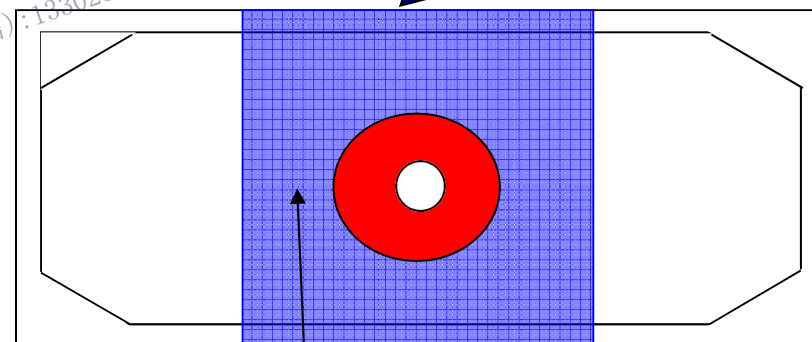
Caused by mechanical impact by pushing PCB and/or PCB rebounding during attachment process

连接过程中推压PCB或PCB回弹引起的机械冲击

- Reexamine the pushing speed
重新检查推进速度
- Reexamine the pushing amount
重新检查推入数量
- Change the shape or/and the material of nozzle
改变喷嘴的形状或者材质

Equipment nozzle shape (metal nozzle) 设备喷嘴形状 (金属喷嘴)

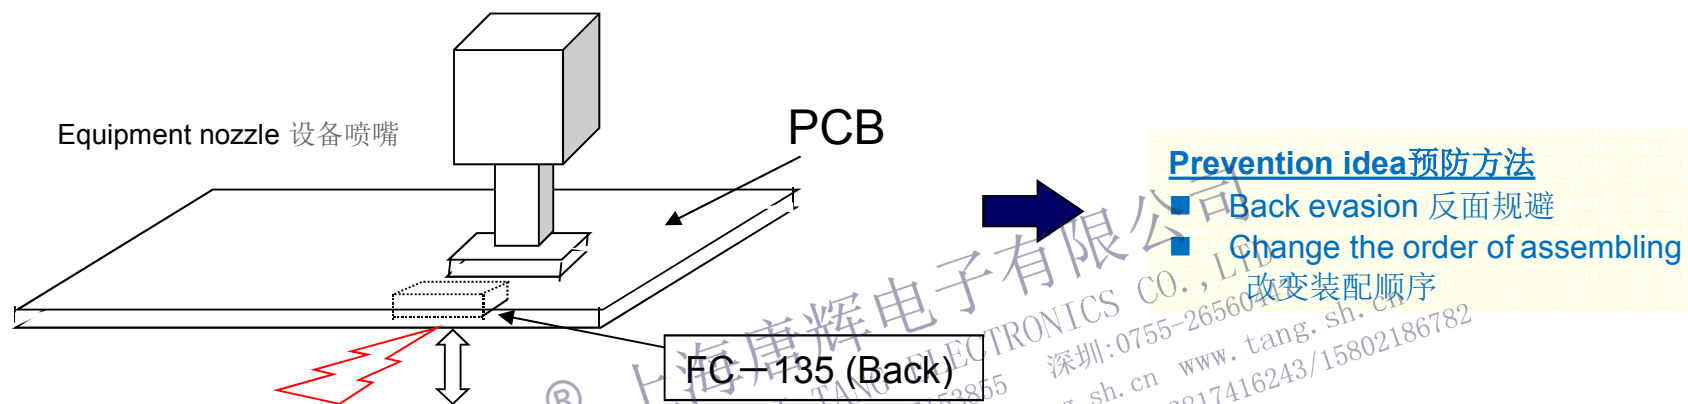
Blue shape (large quadrangle) is better than red shape (small circle)

There is a risk of Lid peeling happening with red shape. 蓝色形状(大四边形) 优于红色形状(小圆形), 红色形状有盖脱落的危险

FC-135

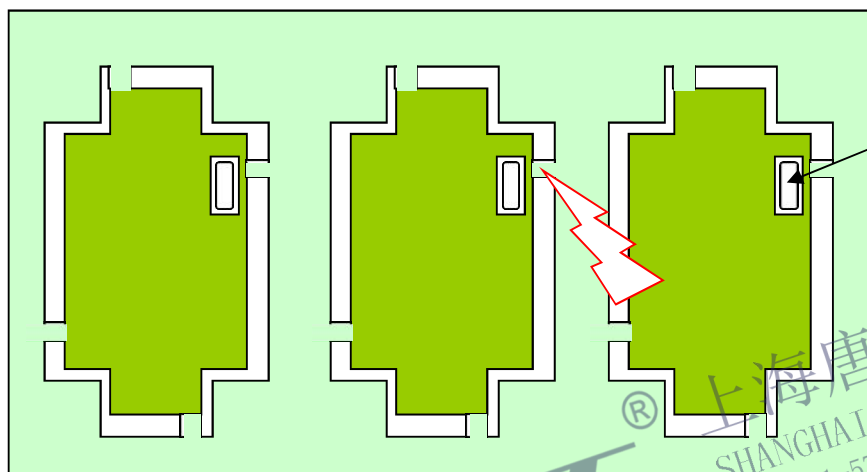
Caused by mechanical impact by PCB bending during back side soldering 反面焊接时PCB弯曲引起的机械冲击

- Change the location of FC-135
改变FC-135的位置

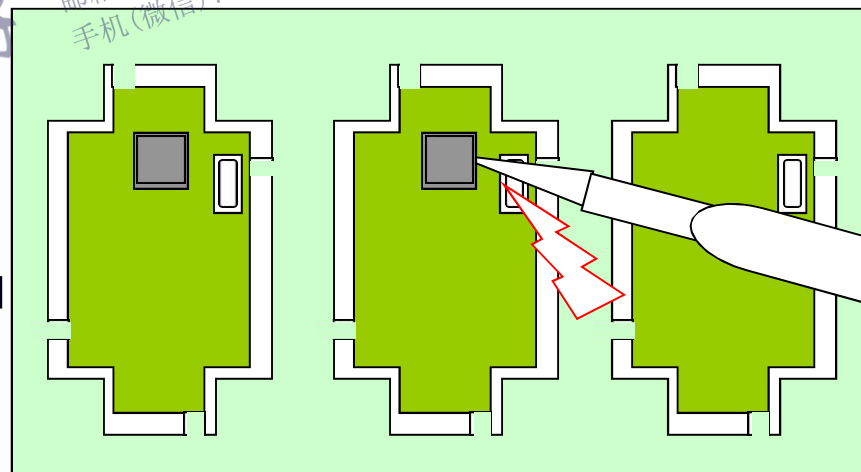
Caused by mechanical impact during PCB separating process 在PCB分离过程中由于机械冲击造成的

- Change the location of FC-135
改变FC-135的位置

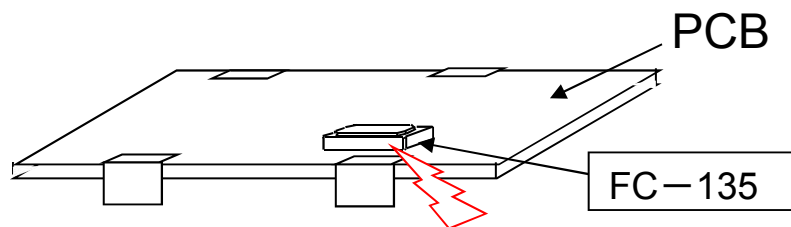
Caused by thermal impact on the glass lid from the iron tip during soldering process 在焊接过程中由热冲击引起的玻璃盖从铁尖上脱落

Caused by mechanical interference
to a PCB holding material

- Change the PCB holding material
更换PCB夹持材料

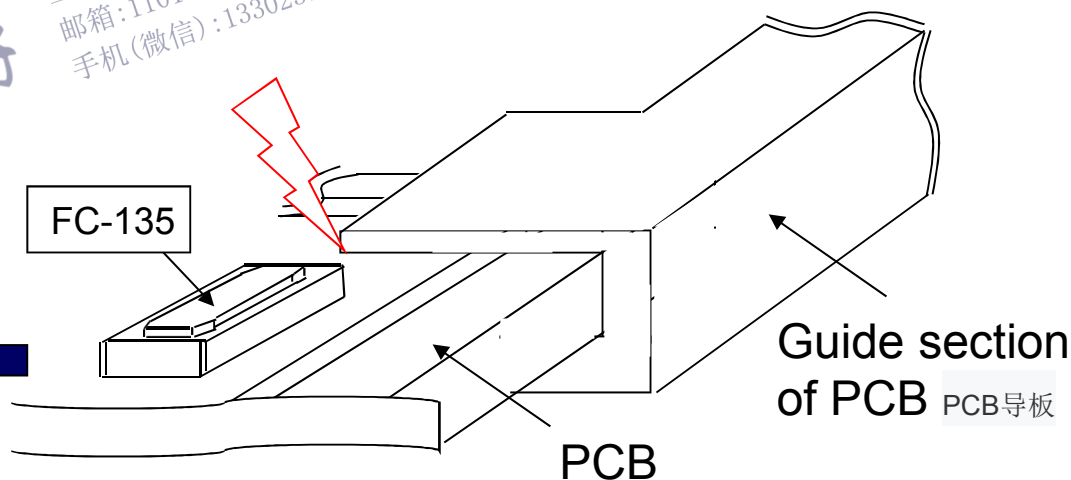
Caused by mechanical interference to a
guide section of PCB 由PCB导板机械干扰引起的

- Change the guide section of PCB
改变PCB的导板
